APPLICATION NO.	FILING DATE	FIRST NAMED INVENTOR	ATTORNEY DOCKET NO.	CONFIRMATION NO.
10/771,812	02/04/2004	Hideaki Matsuhashi	KANEKO.010AUS	3969
7590	10/19/2005		EXAMINER	
MURAMATSU & ASSOCIATES Suite 310 114 Pacifica Irvine, CA 92618			ADDISU, SARA	
			ART UNIT	PAPER NUMBER
			3722	
DATE MAILED: 10/19/2005

Office Action Summary	Application No.	Applicant(s)	
	10/771,812	MATSUHASHI ET AL.	
	Examiner	Art Unit	
	Sara Addisu	3722

DETAILED ACTION

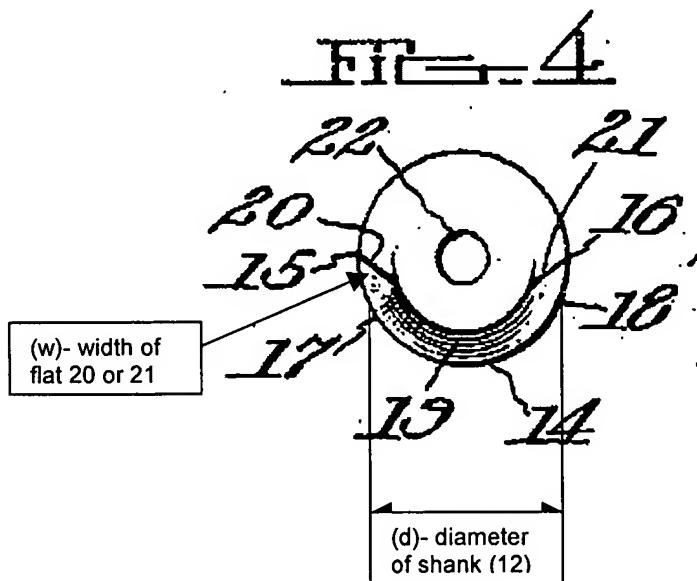
Shoemaker teaches cutting tool (11) having a cylindrical shank portion (12), and a semi-cylindrical body portion (13) having a rake face, straight parallel side cutting edges (15 & 16) and end cutting edge (14) (see figures 1 & 2). Shoemaker also teaches the semi-cylindrical body portion (13) having a half moon shape in cross section ('863, Figures 4 & 5) (note: MSN Encarta online dictionary defines half-moon as:- a pale semicircle at the base of the finger nail. This description of "half-moon" reads

on figure 4 and 5 of Shoemaker's teaching). Shoemaker also teaches the rake face having a flat surface (20 or 21) that has a width (w) that is smaller than the diameter (d) of the cylindrical shank portion (12) (lines 74-76 and see diagram below).
